NABCO ENTRANCES TECHNICAL BULLETIN

ANALOG CONTROL - DOOR HESITATION AND/OR CREEP MODE PROBLEMS

Bulletin Number: **38**

Motor Protector Relay
Part # 24-0952

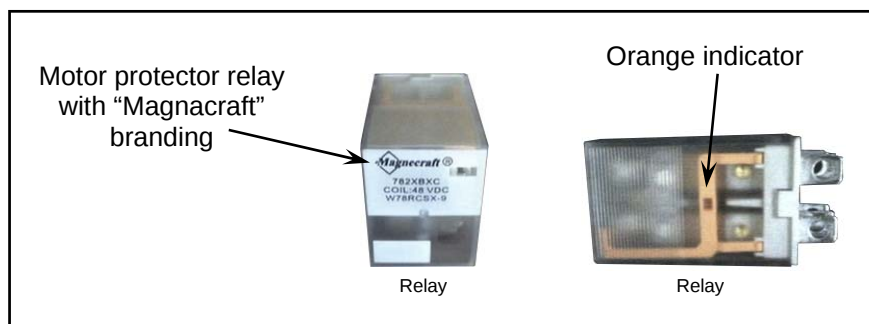
Issue: A small percentage of Gyro Tech swing door analog controls have been reported to have one or more of the following conditions:

1. The unit may hesitate for about 3-5 seconds before opening.
2. Unit may switch back and forth into and out of creep mode.
3. Unit will stay in creep mode.

Reason: The Magnacraft brand motor protector relay with the orange indicator has malfunctioned.

Solution: If you have an analog control with the Magnacraft motor protector relay (with the orange indicator) and are experiencing one or more of the conditions noted above, call Customer Service for a warranty replacement P/N 24-0952. Note: remove the old relay from the control and return to Nabco for replacement. If you have already returned an analog control to Nabco, the Magnacraft relay will automatically have been replaced.
